Responses to EPC June 11, 2019 Comment Letter:

Transportation / Traffic Impact Study (TIS)

Falcon Marketplace (LSC #164350)

Figure 11
**Sight
Triangles**

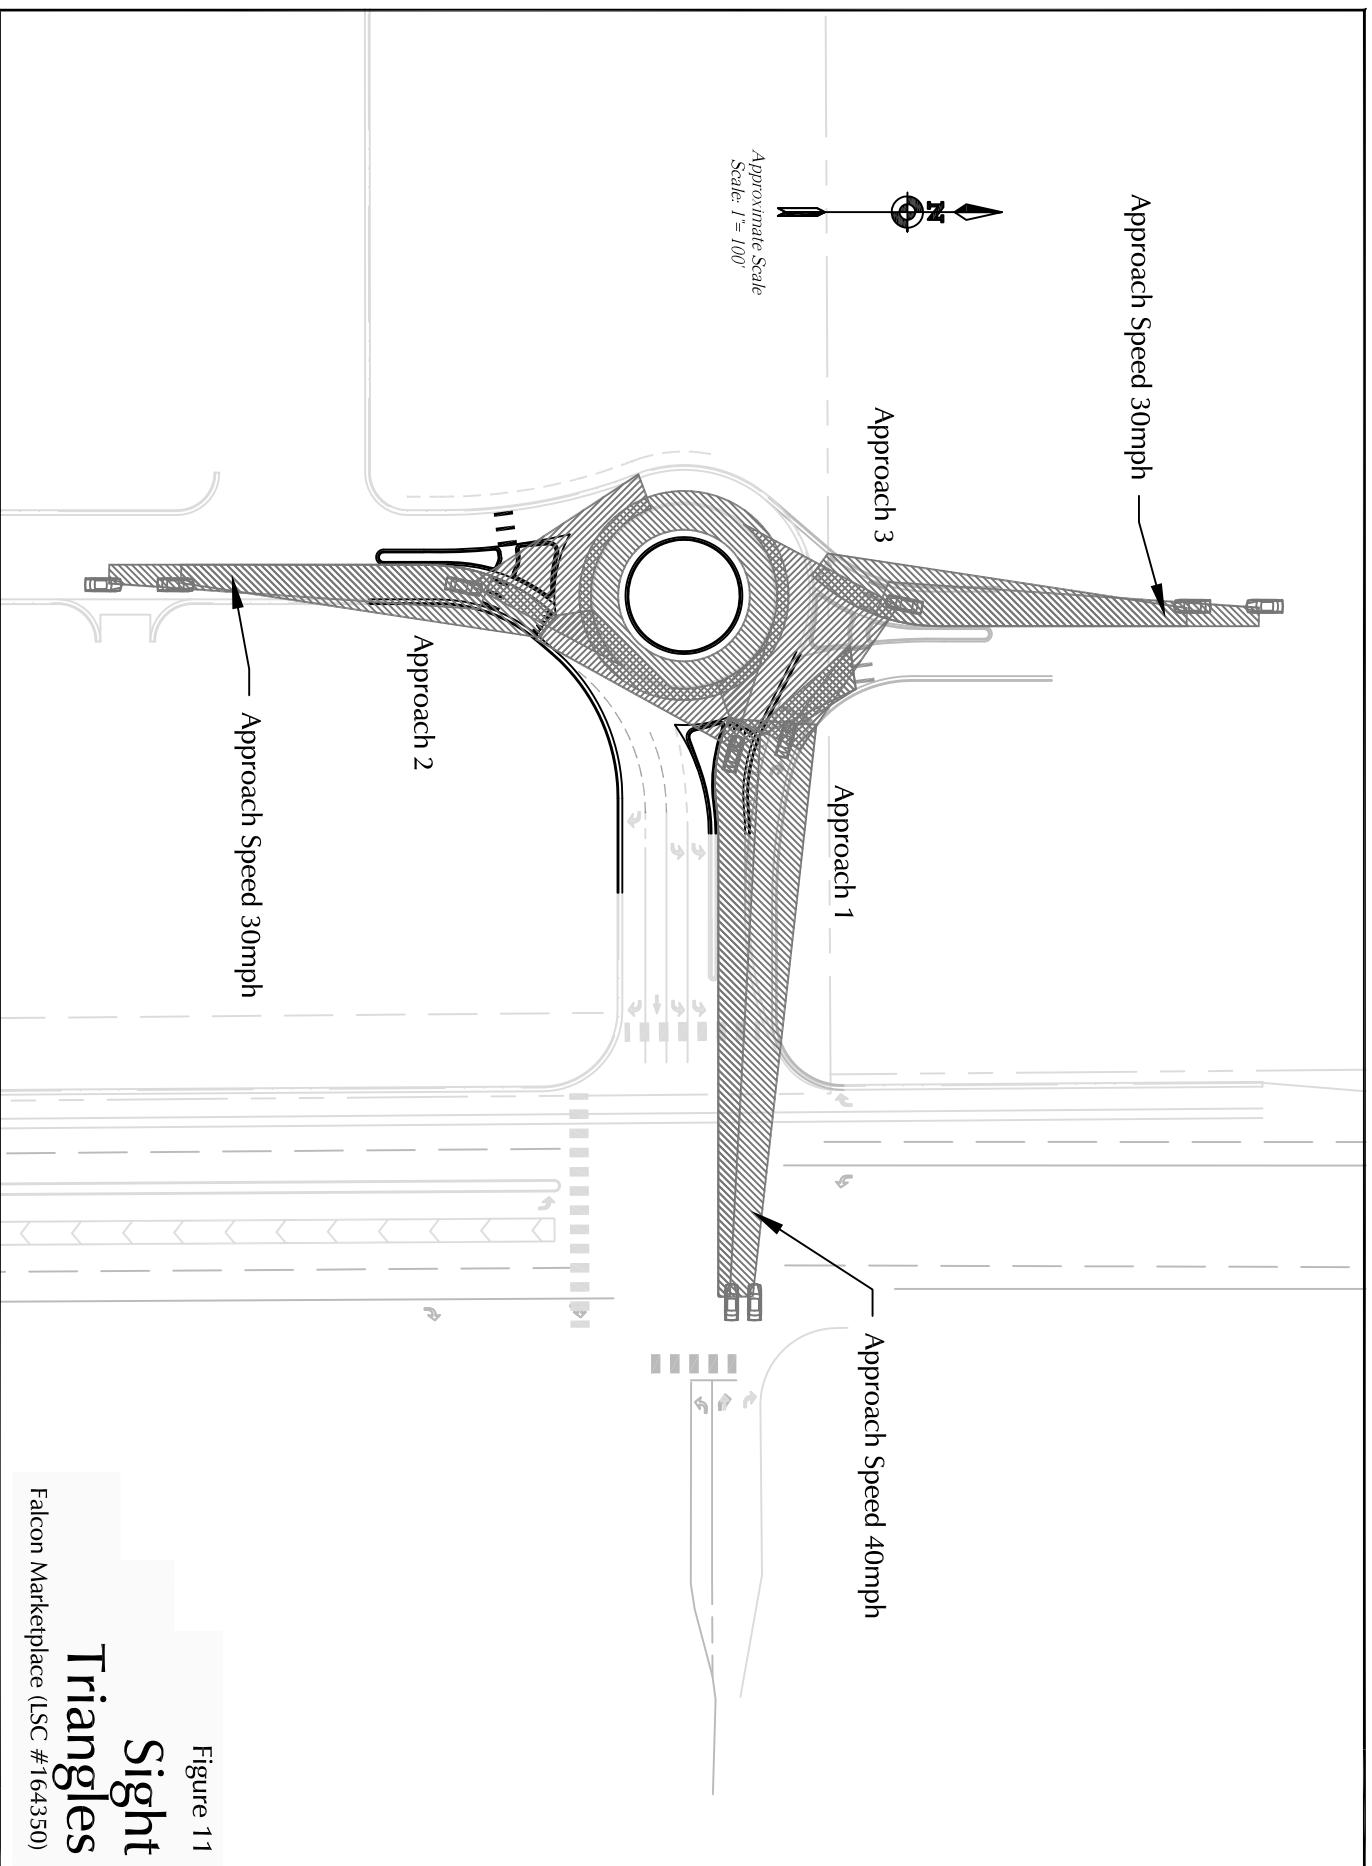
- Sight Triangles – **This have been included in the response memo.**
- Have these been covered:
 - Remove delineators for tear drop **DONE**
 - Signage – “return to shopping center” – U Turn **Completed by Drexel Barrell.**

Figure 1b

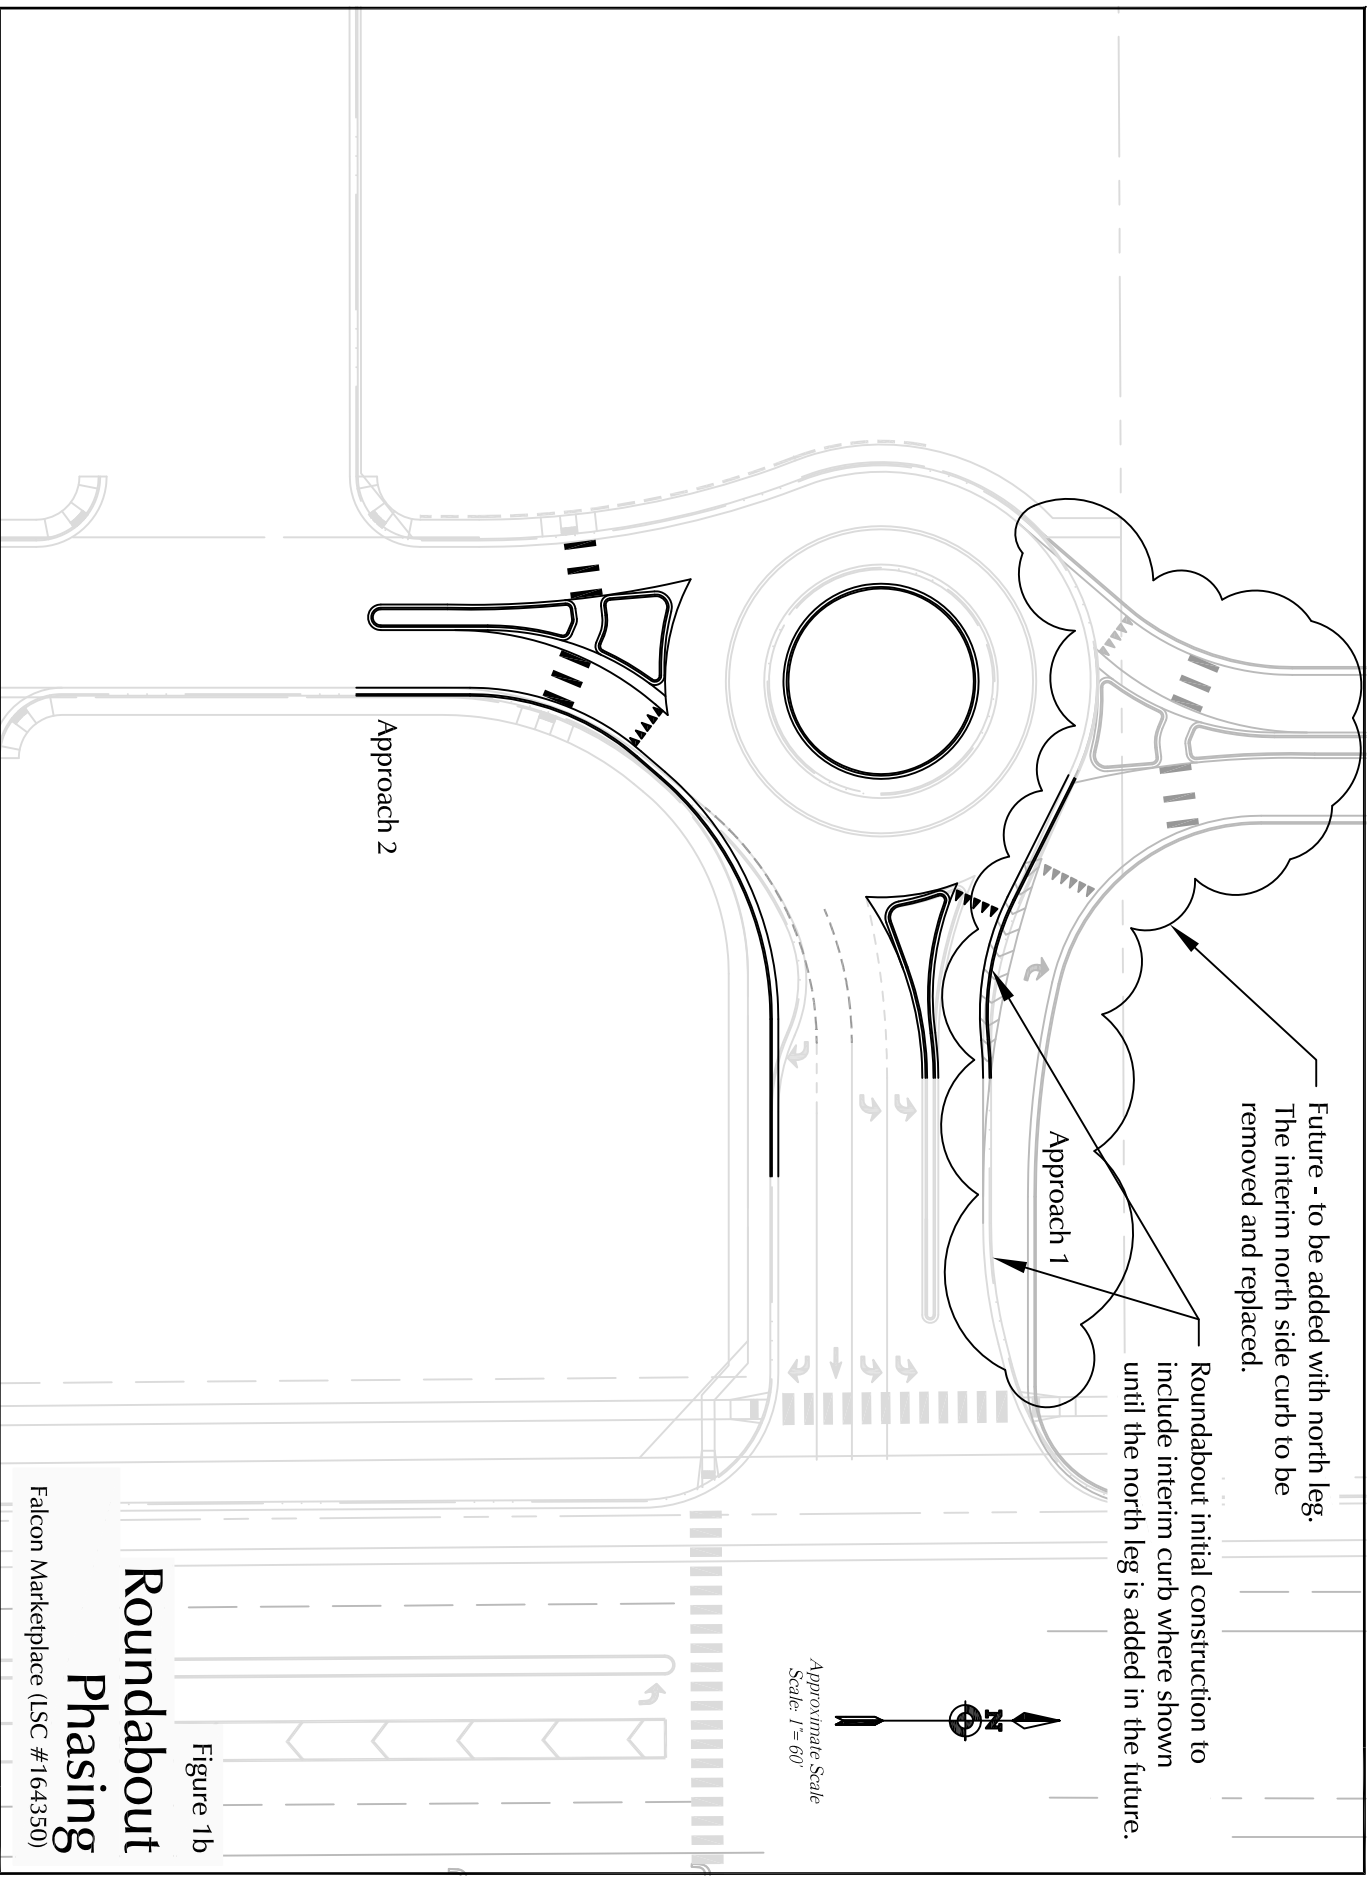
1. *We removed the interim teardrop design that prevented u-turns from northbound to southbound.*
2. *We also removed the interim design on the departure to Approach 1.*
3. *Removing these interim conditions allowed us to increase the Phi angles to 21 degrees for WB and SB and 24 degrees for NB.*
4. *The fastest paths for the three approaches are now 27mph for WB and 24mph for NB and SB. The 27 mph for WB is just over the recommended maximum of 25mph but will be fine once the WB RT lane is added as a two lane approach can be up to 30mph. The 27mph fastest path was the primary reason we proposed the teardrop interim condition to avoid any vehicles that would conflict with the WB entry prior to the north leg being constructed. The good news is we now have a Phi angle of 21 degrees – in my opinion the 27mph fastest path would be an issue if the Phi were below 20 degrees.*
